PLAN COMMISSION/HISTORIC PRESERVATION COMMISSION AGENDA

Wednesday, October 25, 2023 at 7:00 PM

To: Village of Mount Horeb Plan Commission
From: Village Planner Ben Rohr, AICP
Date: October 25, 2023
Re: Village Planner's Site Plan and Design Review Comments for Proposed Storage Shed for Children's Community School at 1175 Cox Drive.

To: Village of Mount Horeb Plan Commission
From: Village Planner Ben Rohr, AICP
Date: October 25, 2023
Re: Village Planner's Site Plan and Design Review Comments for Proposed Exterior Building Changes for Madison Area Rehabilitation Center (MARC) on Lot 158 Commerce Drive.

← Proposed
9'x7'
STORAGE
SHED
SET ON
EXISTING
CONCRETE
SLAB

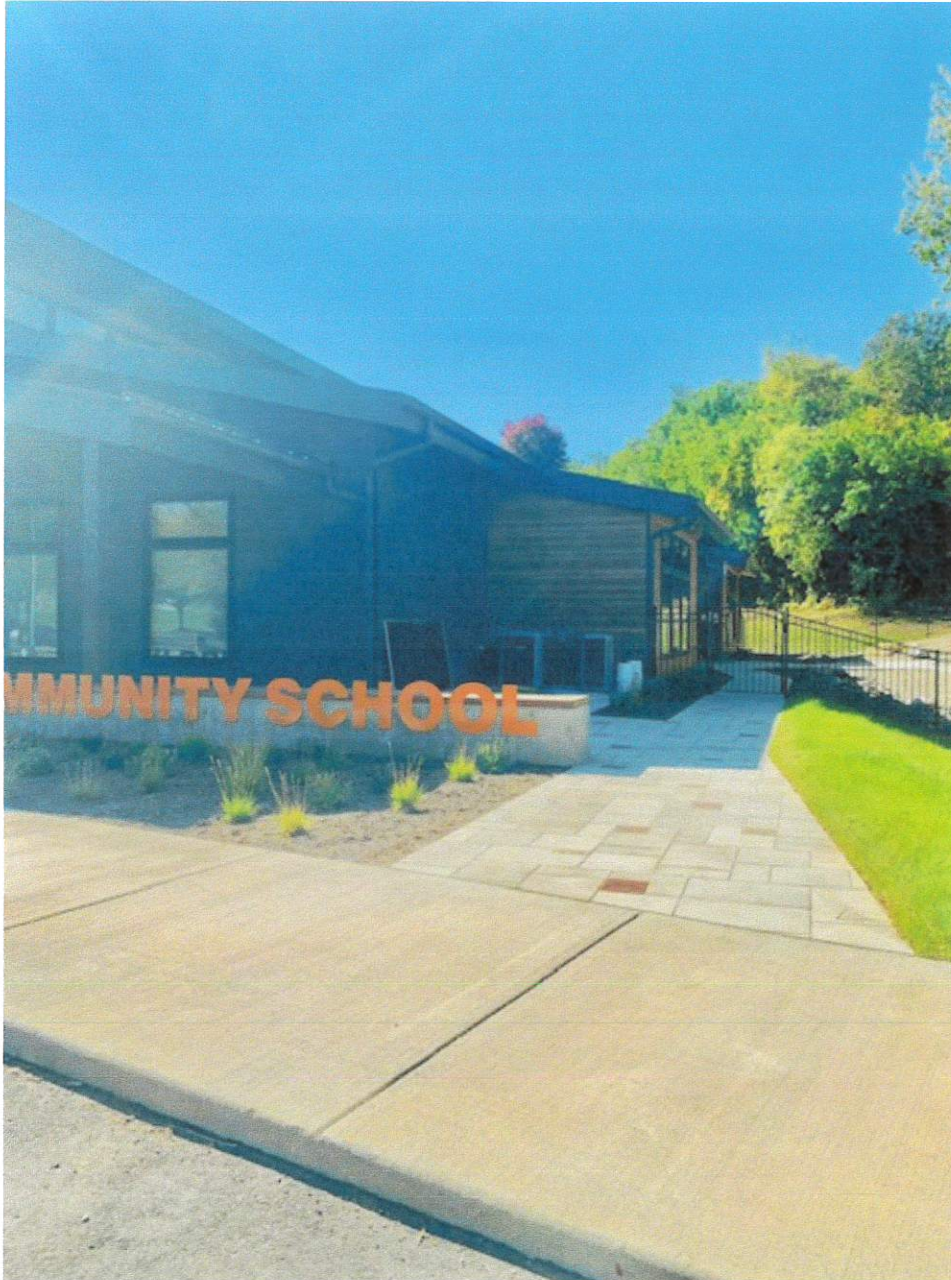
- Proposed Today: The proposed shed does not include any direct screening from Springdale Street. There are existing trees and bushes along the northern property line that shield the structure from view, however with the new sidewalk connection to the property, the shed will be visible at times by travelers along Springdale Street. I recommend the Plan Commission discuss if the existing vegetation is adequate screening for the proposed storage shed.

1. Plan Commission discussion and determination on whether the existing vegetation along the northern property line provides adequate screening for the proposed storage shed in this location. See photos on the next page.
2. Any other comments or recommendations of the Plan Commission or Village staff.

OVERALL ROOF PLAN

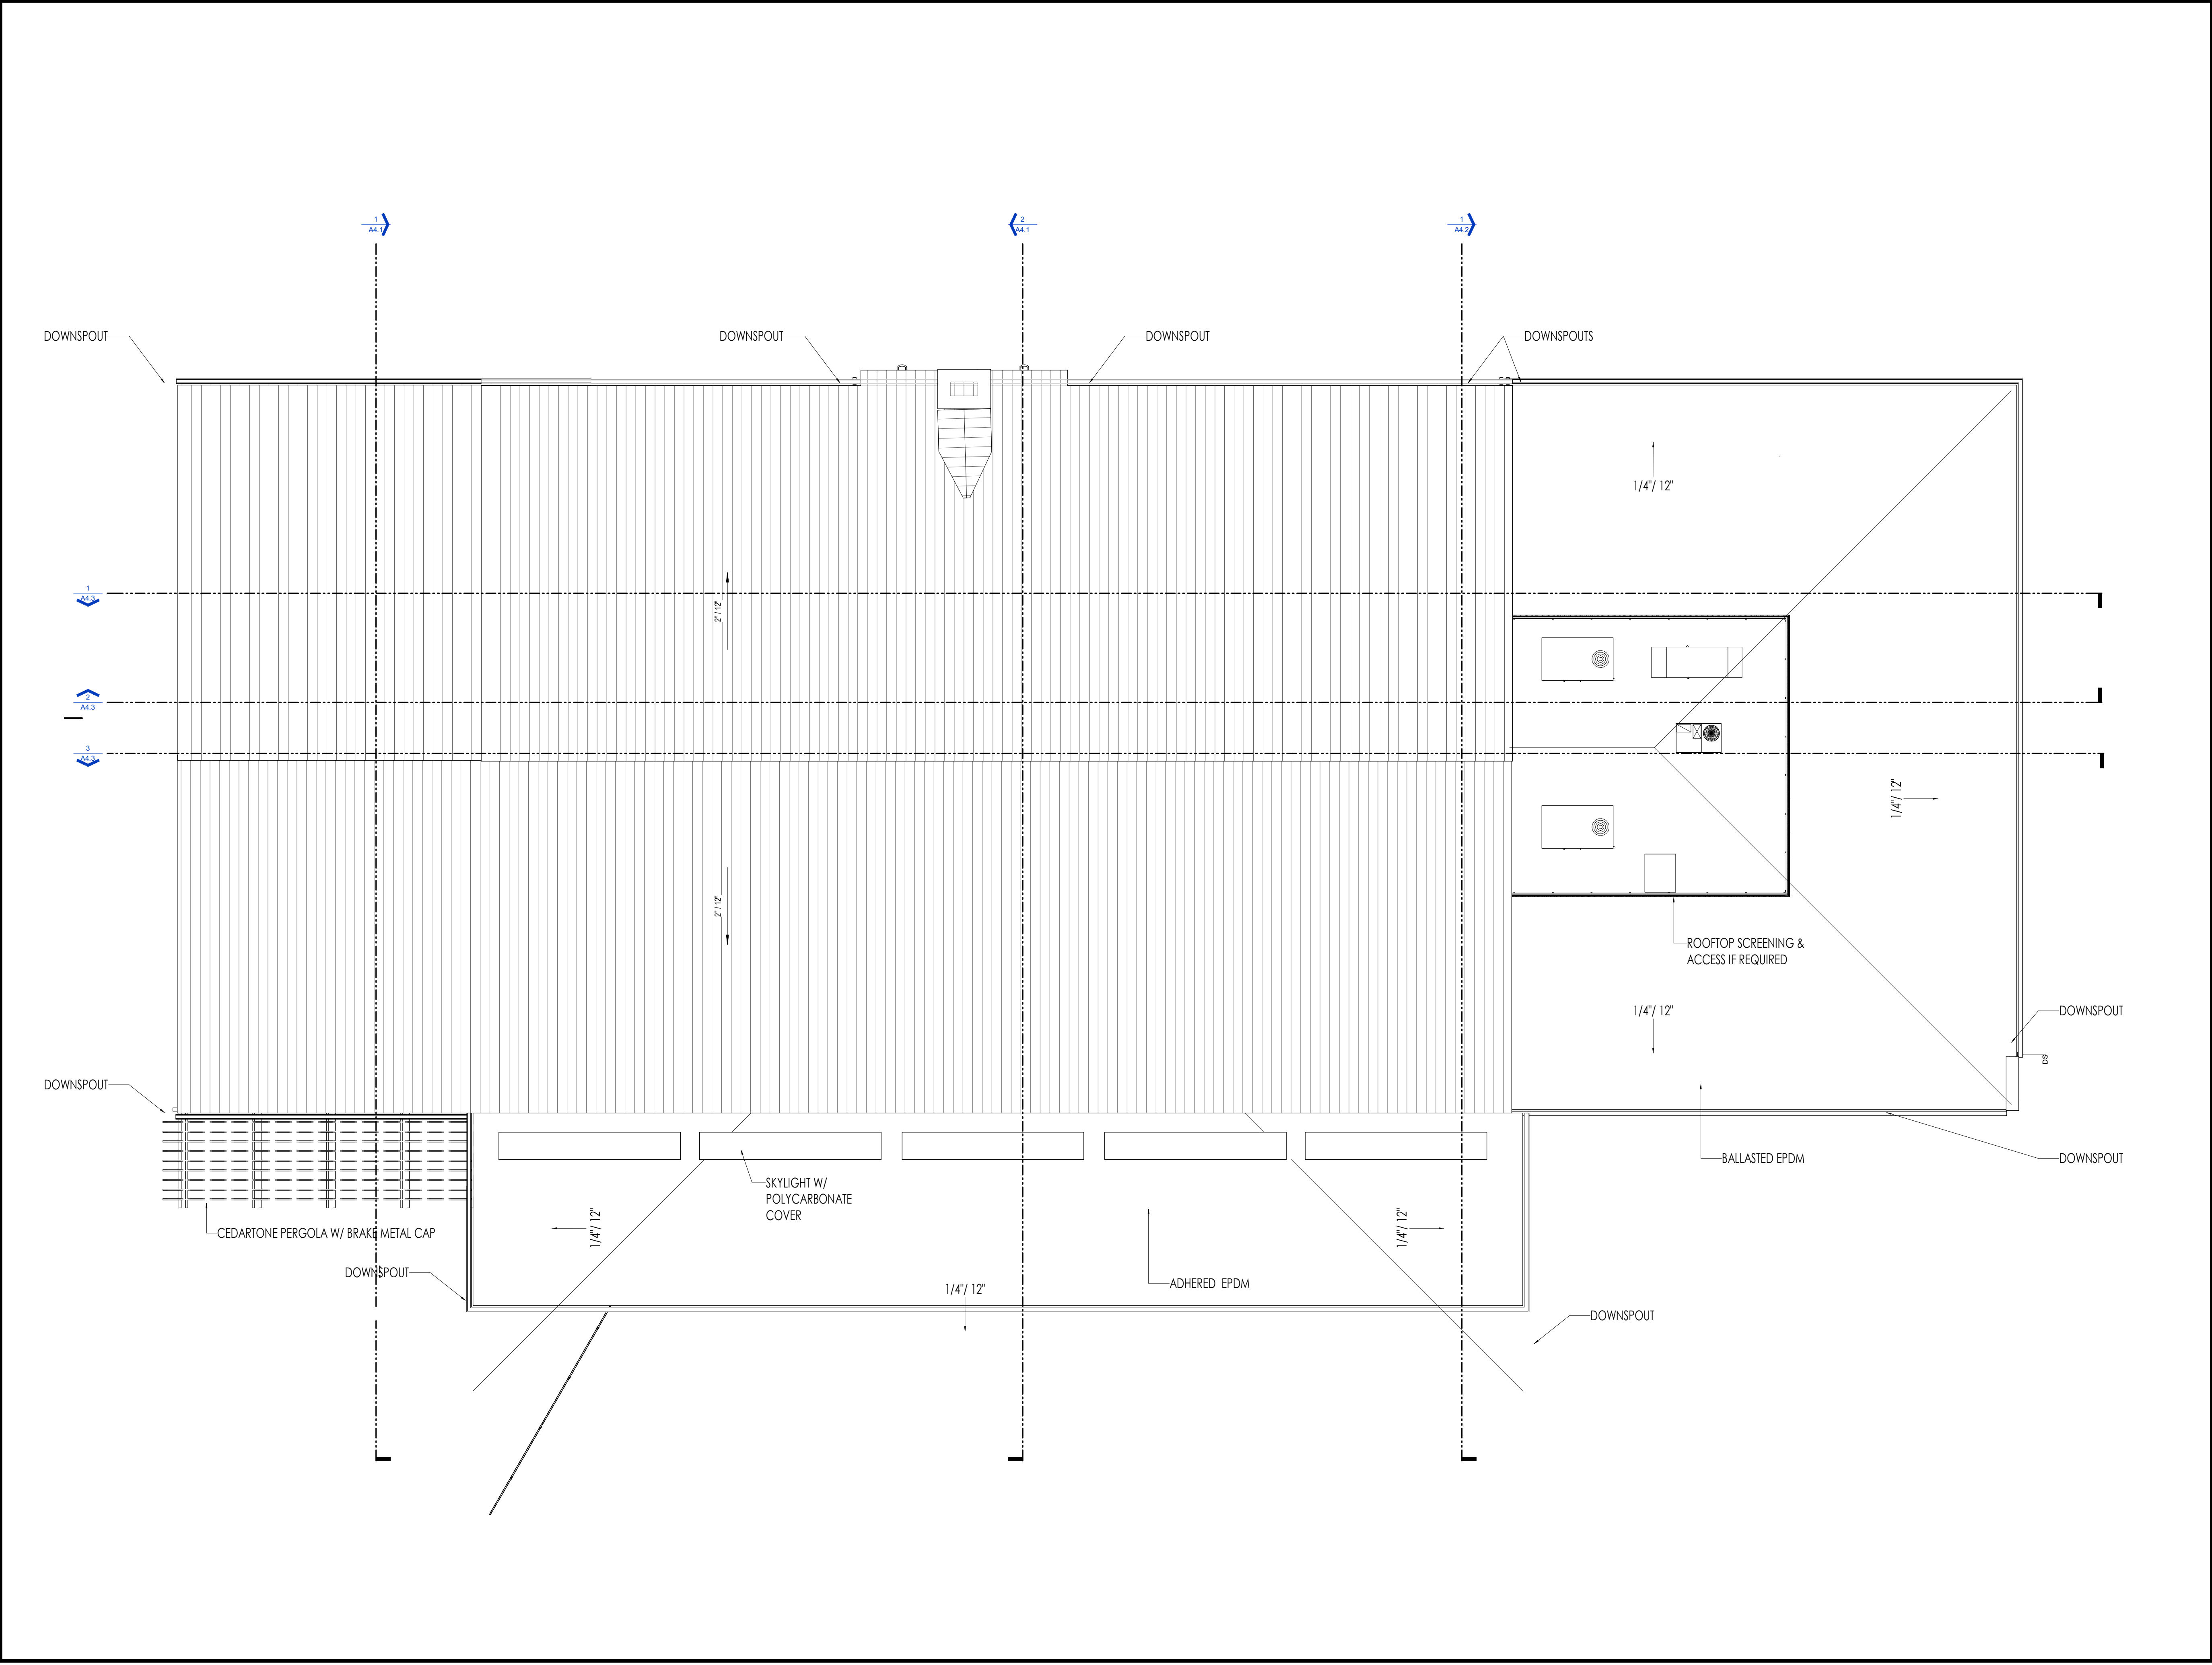
- This requirement is not applicable as it does not have a frontage along Springdale Street. However, the proposed roof has multiple pitches the creates a de facto tower element in the center of the building. The center roof pitch on the west side of the building is approximately 3 feet taller than roof pitch on the eastern side of the building, which will allow natural light into the building. The chimney that was previously included within the plans is now proposed to be removed.

1 EAST ELEVATION
1/8" = 1'-0"

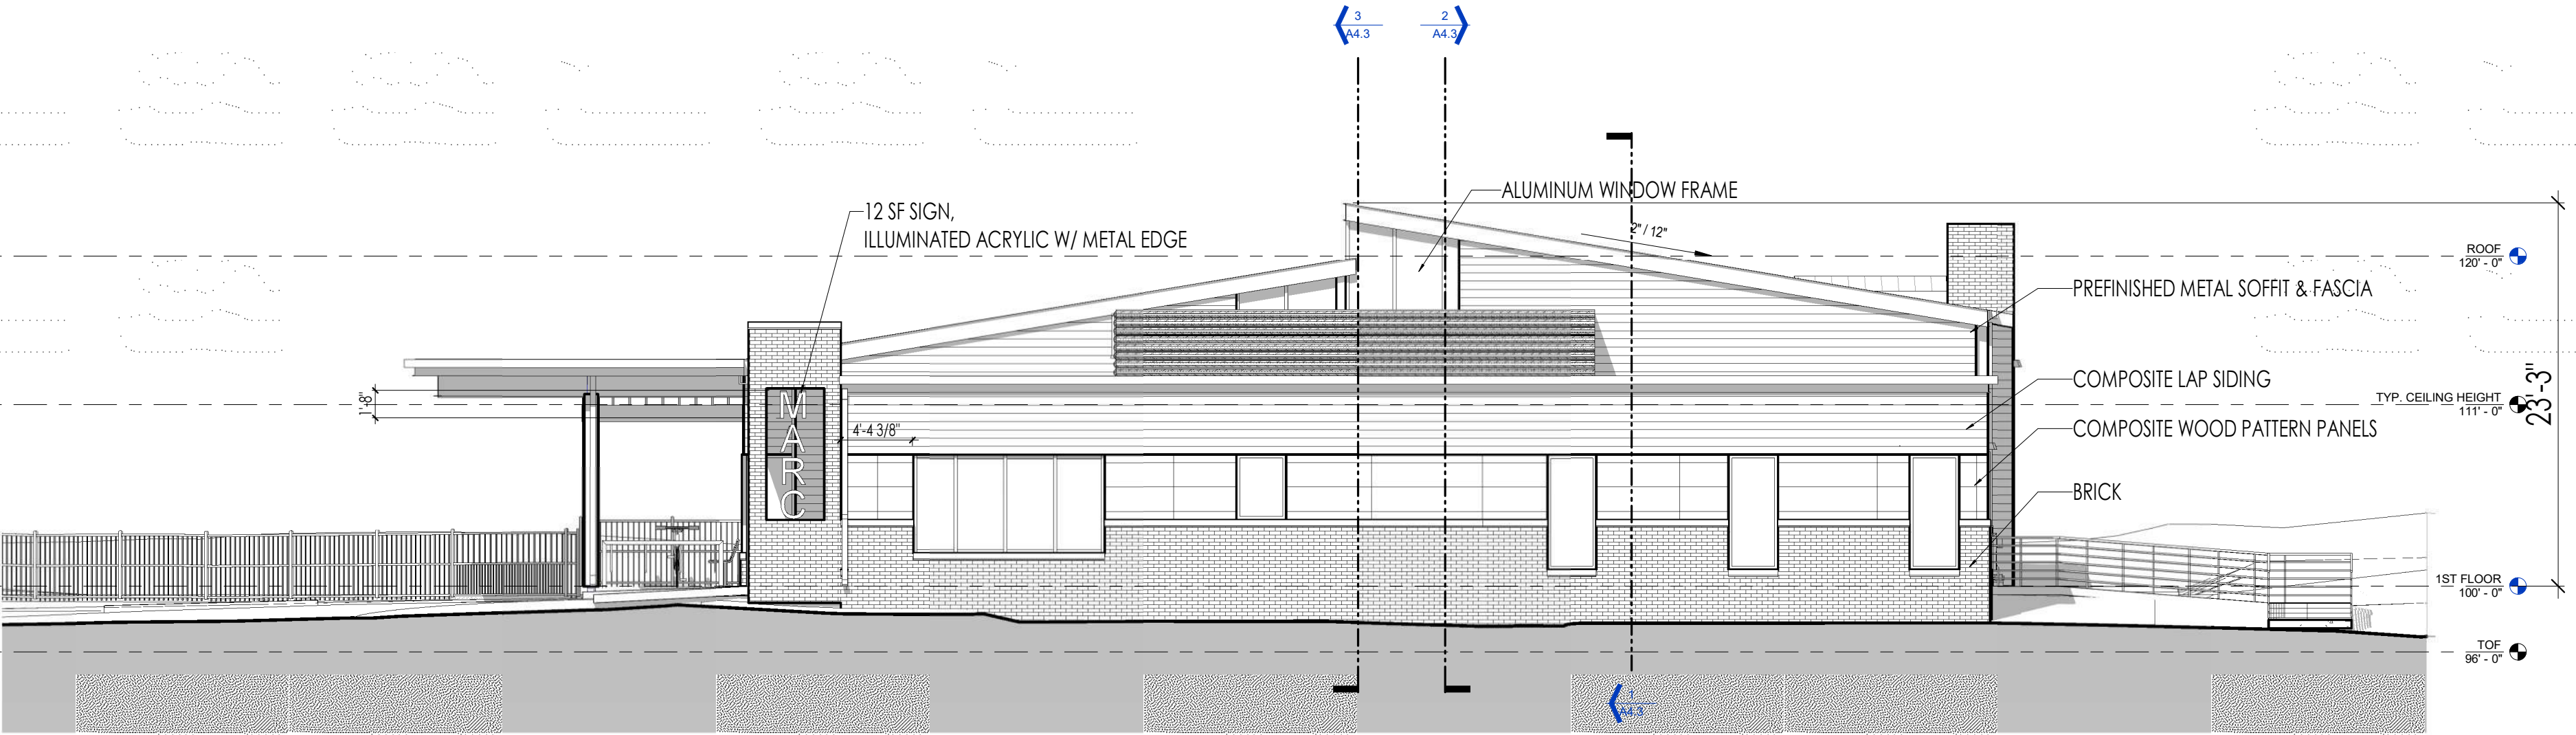
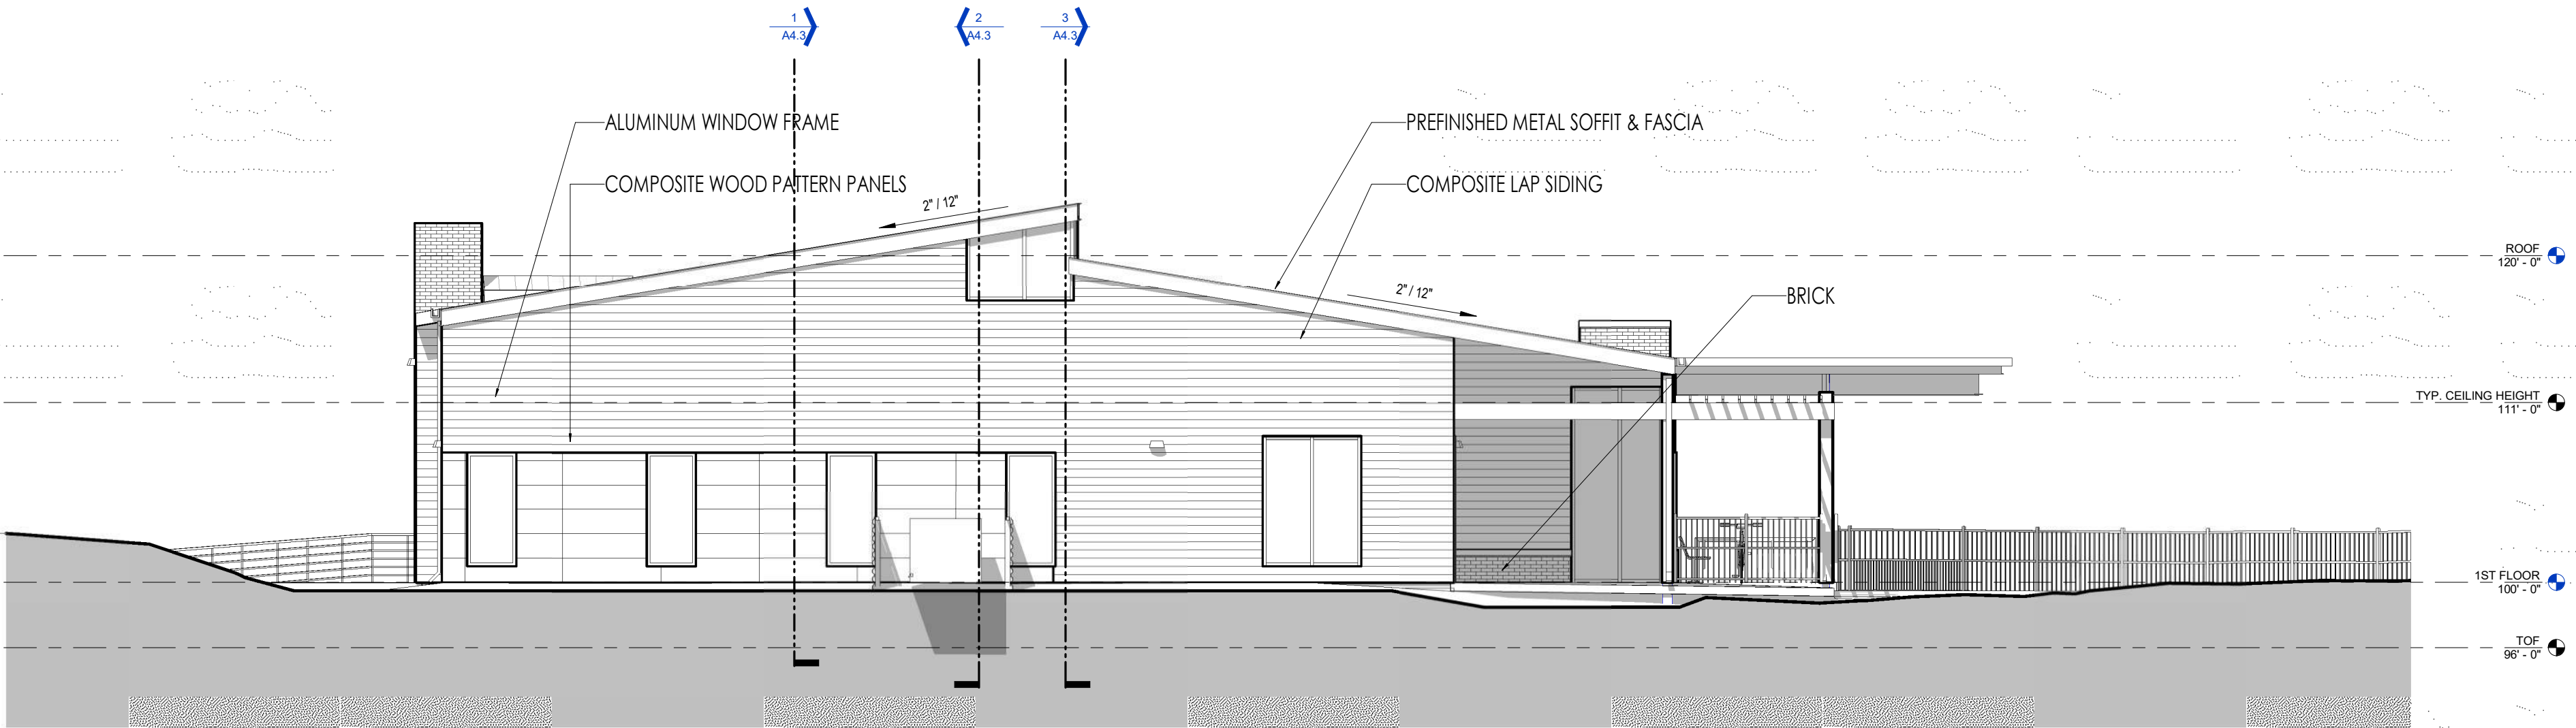
- Overhead garage doors on west elevation changed from all glass to a solid door with wood tone and accent windows.
- The patio on the east elevation enlarged from 170 square feet to 645 square feet and now includes benches and planters, with some reconfiguration of plantings along the western facade.

- Previously Approved in April 2023: This requirement is met on all portions of structure using brown, grey, and brick colors.
 - Proposed Today: This requirement is not met. The proposed plan changes include black and grey exterior colored siding with brown, wood tone accents on all facades.
